Submittal Records

Architect: Snyder Architects Inc.	Date: 2024-07-31
Attention: Amit Patel, Anil Gokarn, Avinash Garde, Mike Wilding, Jamie Leach, Shakil Manashiya, Jake Graham	Project: Gymnasium Addition at Glenview PS
Subcontractor: Kirk Mechanical	Shop Drawings – Mechanical HVAC

DEI Glenview PS Additions

Tag: HVAC-1

Dimensional Drawings - 20 Ton PKGD Precedent Unitary Rooftops

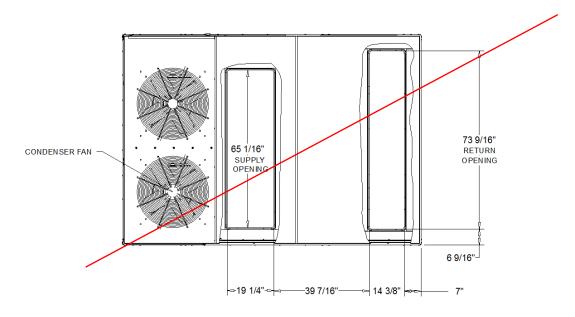
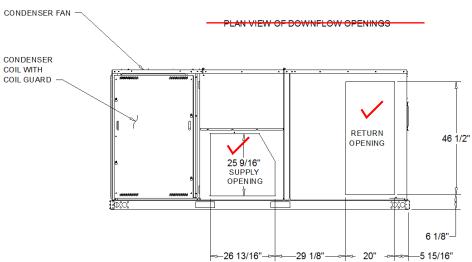
Horizontal S/A and R/A openings required (on side of unit) HORIZONTAL AIR FLOW OPENING Consulting Engineers 1 1 HEAT PUMP / HYBRID HEAT HIGH EFFICIENCY MECHANICAL ELECTRICAL AQUATIC This review by DEI & Associates Inc. is for the sole purpose of ascertaining DIMENSION DRAWING conformance with the general design concept. This review shall not mean that DEI & Associates Inc. approves the detail design inherent in the shop drawings, responsibility for which shall remain with the contractor submitting same, and such review shall not relieve the contractor of his responsibility for errors or omissions in the shop drawings or his responsibility for meeting all requirements of the construction and contract documents. Reviewed Reviewed As Noted **Not Reviewed Revise and Resubmit Equipment Submittal** Page 9 of 17
